CALIFORNIA COASTAL COMMISSION

COASTAL DEVELOPMENT PERMIT APPLICATION

Application number3-01-111, Pelican Point Riverwall

Project descriptionInstall a driven sheet-pile metal wall along roughly 715 linear feet of the Pajaro River and Watsonville Slough sides of the Pelican Point condominium portion of the Pajaro Dunes residential development.

RIVER/SLOUGH
SIDE OF
SHEETPILE WALL

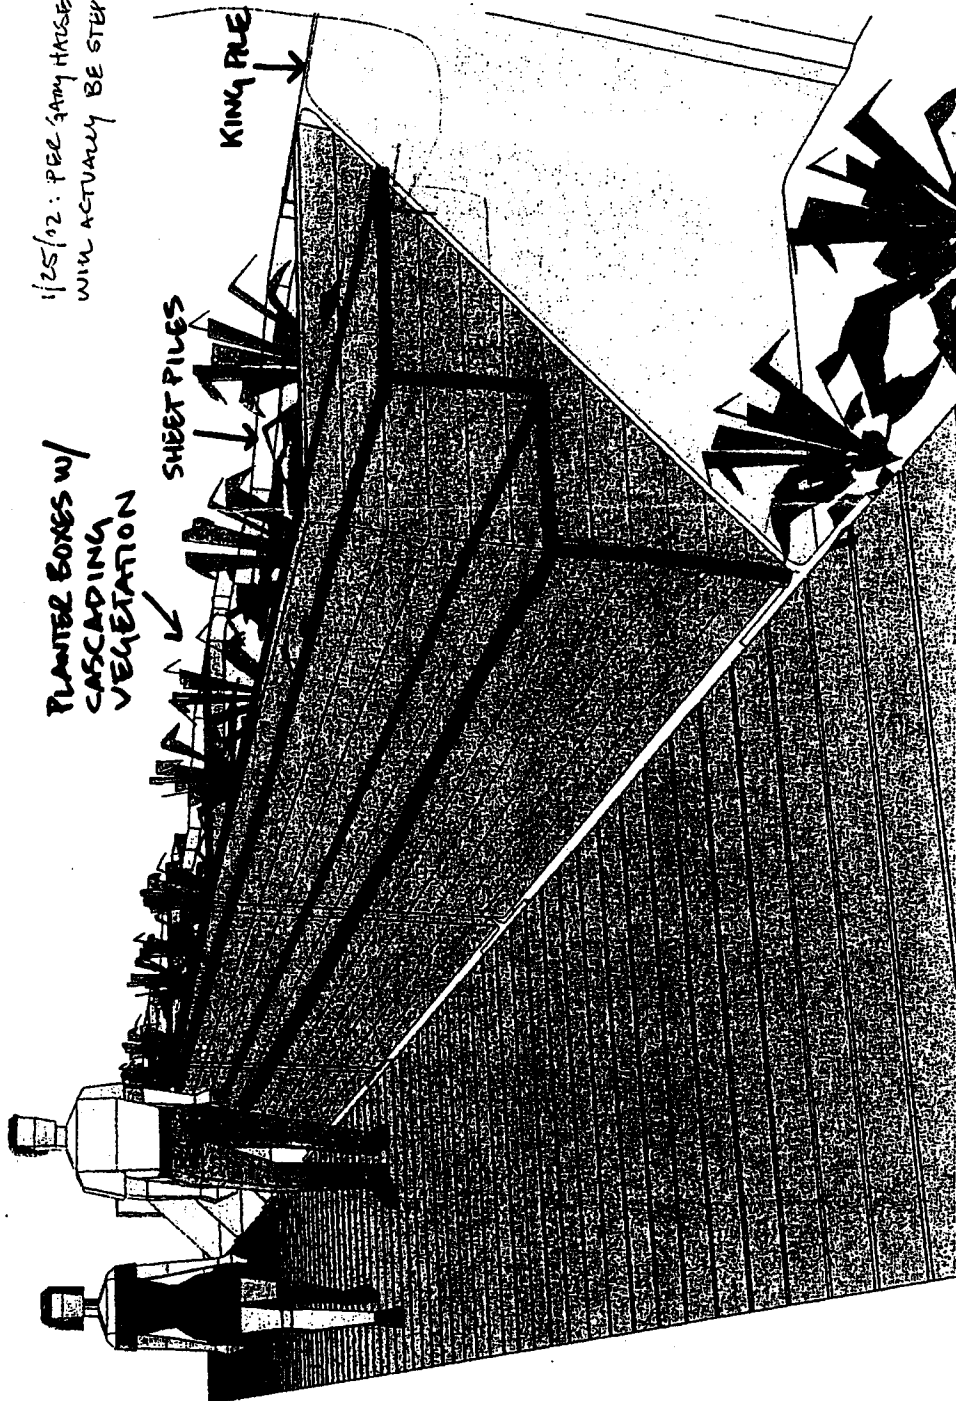
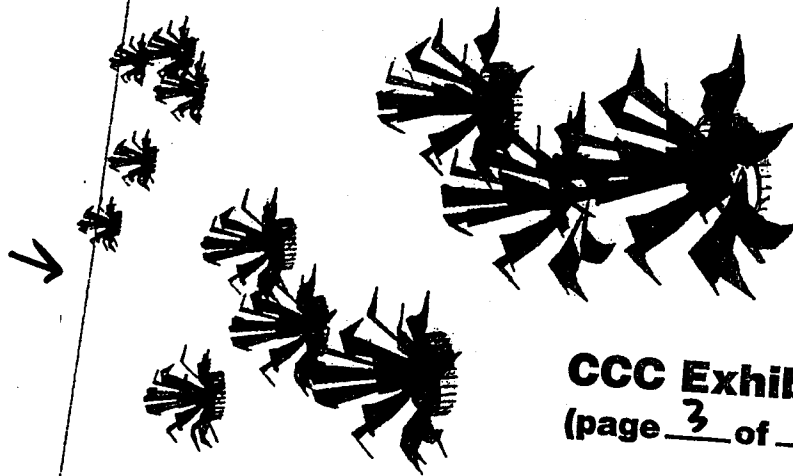
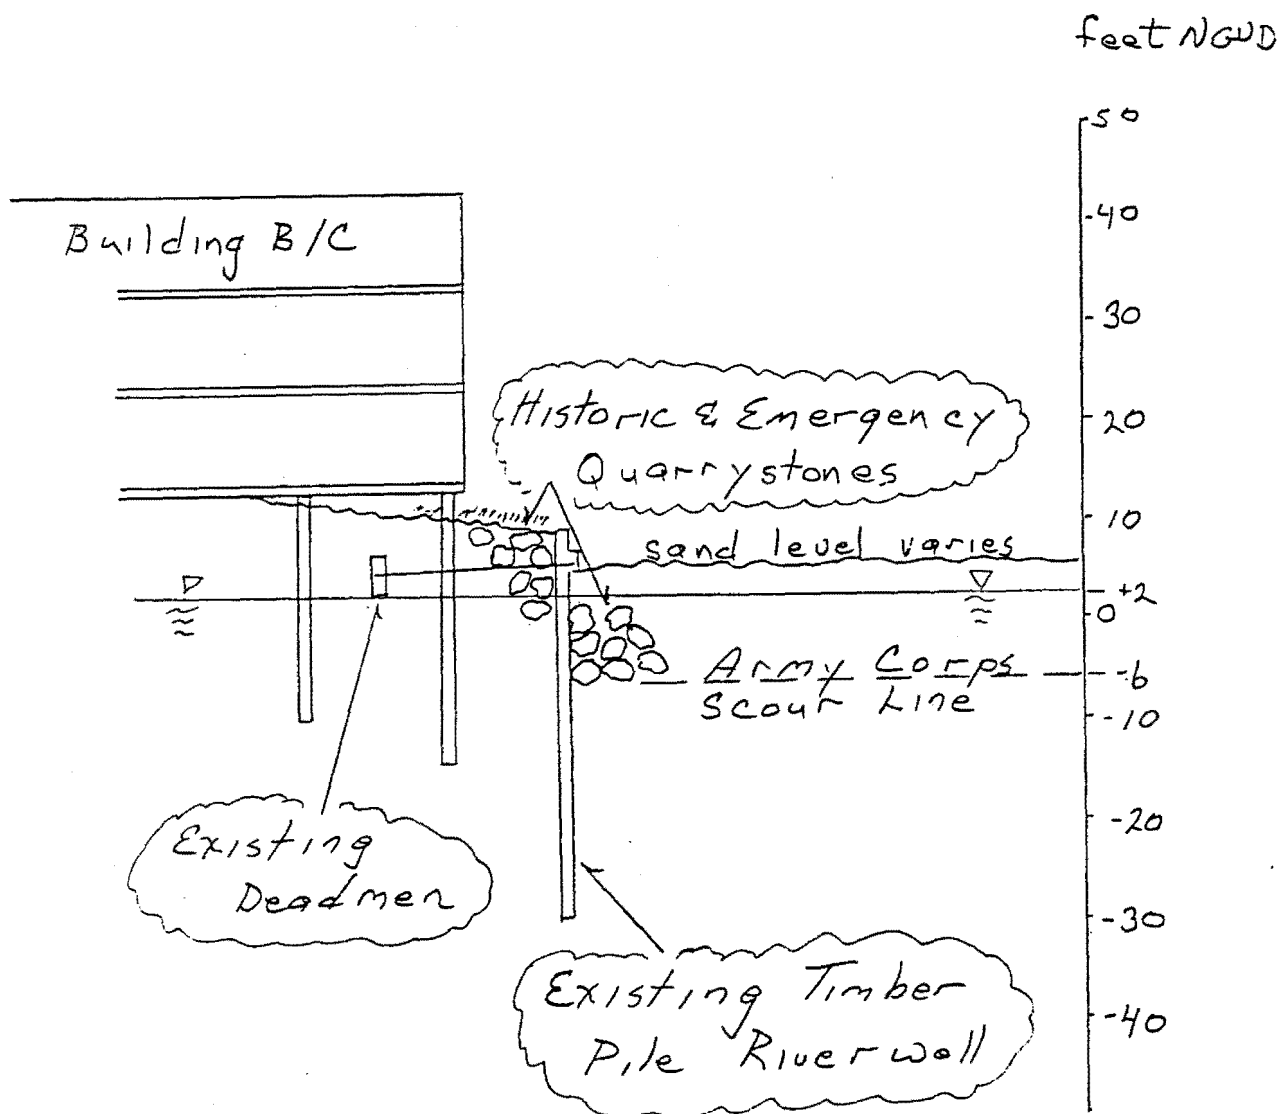
1/25/12: PER GARY HATSEY,
WILL ACTUALLY BE STEPPED

Undulating Wall Concept
21 March 2002

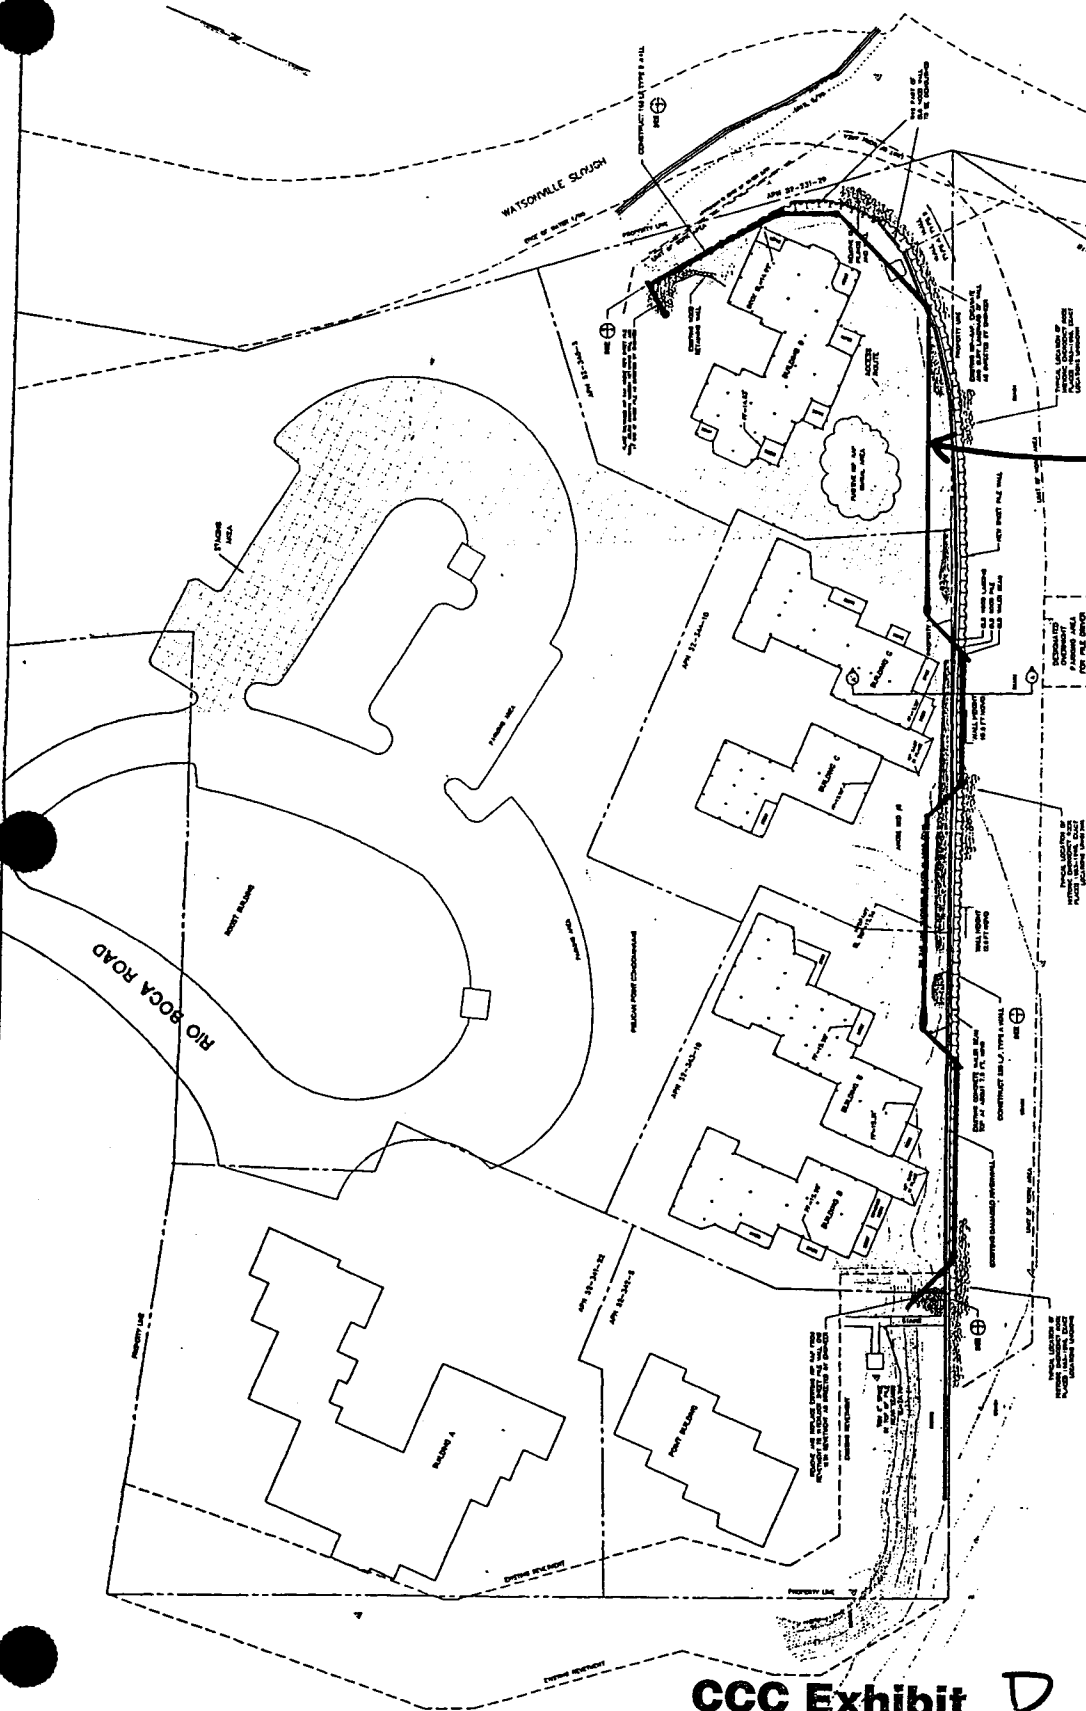
- (b) **Removal of Structures on the Pajaro River/Watsonville Slough Side of the Undulating Wall.** The Revised Sheetpile Wall Plans shall provide for the removal of the existing wood pier and lagging wall, and the removal of all rip-rap, sand bags, and other associated structures from the Pajaro River/Watsonville Slough side of the undulating sheetpile wall location. The Revised Sheetpile Wall Plans shall indicate that rip-rap and sand bags may be used to back fill on the inland (condominium) side of the sheetpile wall, but that all other structures removed, including any rip-rap or sand bags not used for back fill purposes, shall be removed off-site and appropriately disposed of.

This revised alternative still raises the same temporary impact and Coastal Act issues identified above for the proposed project, but it eliminates any permanent coverage of ESHA and State Parks land on the river/slough side of the existing wall, consistent with the Coastal Act. Thus, this approval is conditioned for revised final plans for the undulating wall alternative as modified to move the wall inland at the two locations where the Applicant's undulating wall concept plans show it riverward (see exhibit E for approval details in site plan view). Such plans must minimize any necessary construction impact areas on the river side of the existing wall to the absolute minimum necessary. See special condition 1.

1. **Revised Sheetpile Wall Plans.** PRIOR TO ISSUANCE OF THE COASTAL DEVELOPMENT PERMIT, the Permittee shall submit Revised Sheetpile Wall Plans to the Executive Director for review and approval. The Revised Sheetpile Wall Plans shall be substantially in conformance with the plans submitted to the Coastal Commission (*Pelican Riverwall Repair Plan* by Haro, Kasunich and Associates Inc. dated received in the Coastal Commission's Central Coast District Office January 25, 2002) but shall show the following changes to the project:

RESTORATION AREA DETAIL

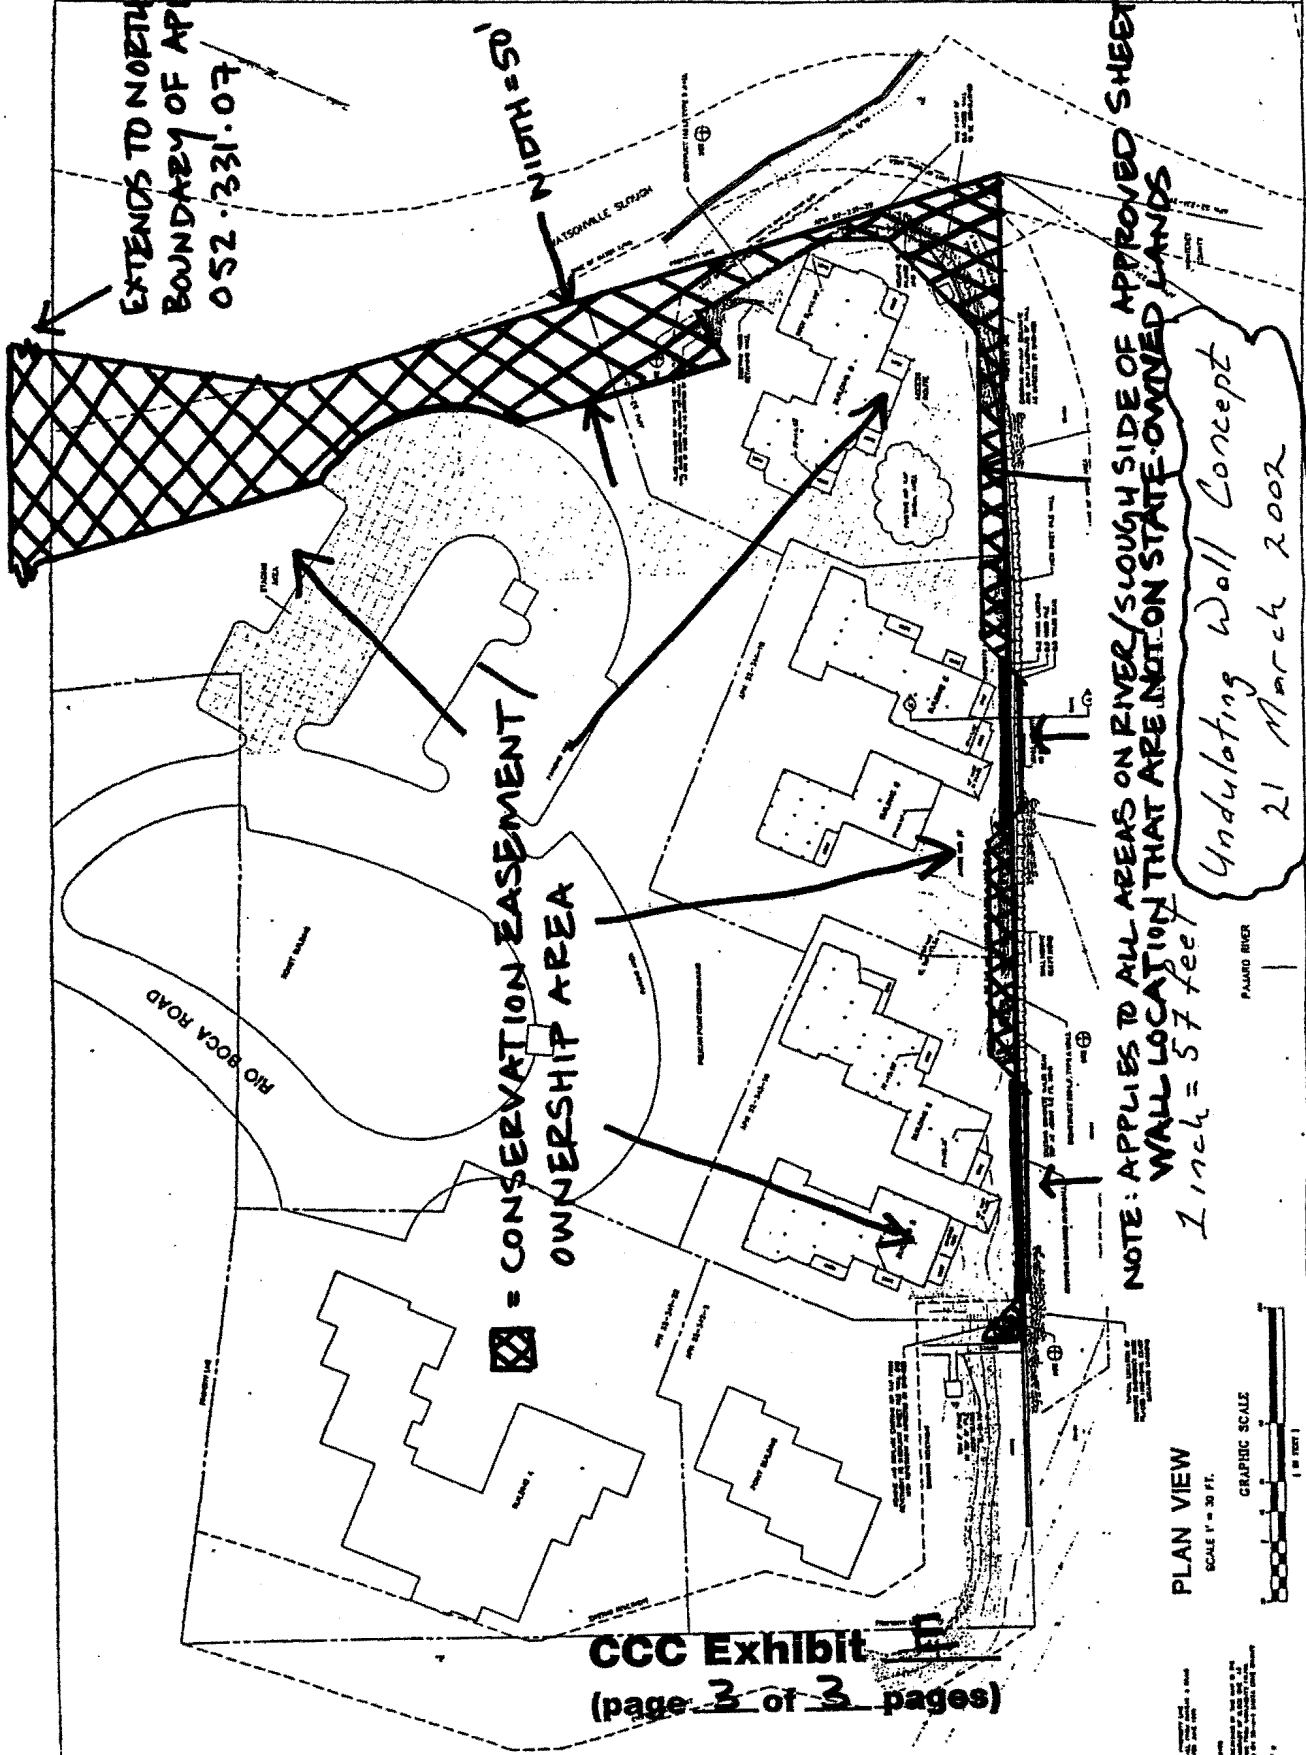
- (a) **Expanded Restoration Area Adjacent to Sheetpile Wall.** The Revised Restoration Plan shall provide for high quality dune and slough restoration of all areas located on the Pajaro River/Watsonville Slough side of the revised undulating sheetpile wall location (identified in the approved Revised Sheetpile Wall Plans per Special Condition 1 above); see page 2 of exhibit E for graphic depiction of this area.

- (b) **Expanded Restoration Area Adjacent to Watsonville Slough.** The Revised Restoration Plan shall provide for high quality wetland/upland restoration and habitat enhancement in the area north of the sheetpile wall as shown on page 2 of exhibit E. All invasive non-natives shall be removed from this area, and significant trees shall be retained.

All areas on the river/slough side of the sheetpile wall within the construction zone must be restored to provide high quality habitat (see restoration area detail in exhibit E). The Applicant will need to submit a revised restoration plan for this purpose consistent with the Commission's generally accepted parameters for such plans. See special condition 2.

The area north of the project site on the Applicant's property between the waters of Watsonville Slough and the paved roadway area (i.e., the general area for which the Applicant has proposed a conservation easement) must be restored to provide high quality slough habitat. The revised restoration plan must be extended to cover this area as well (see restoration area detail in exhibit E). See special condition 2.
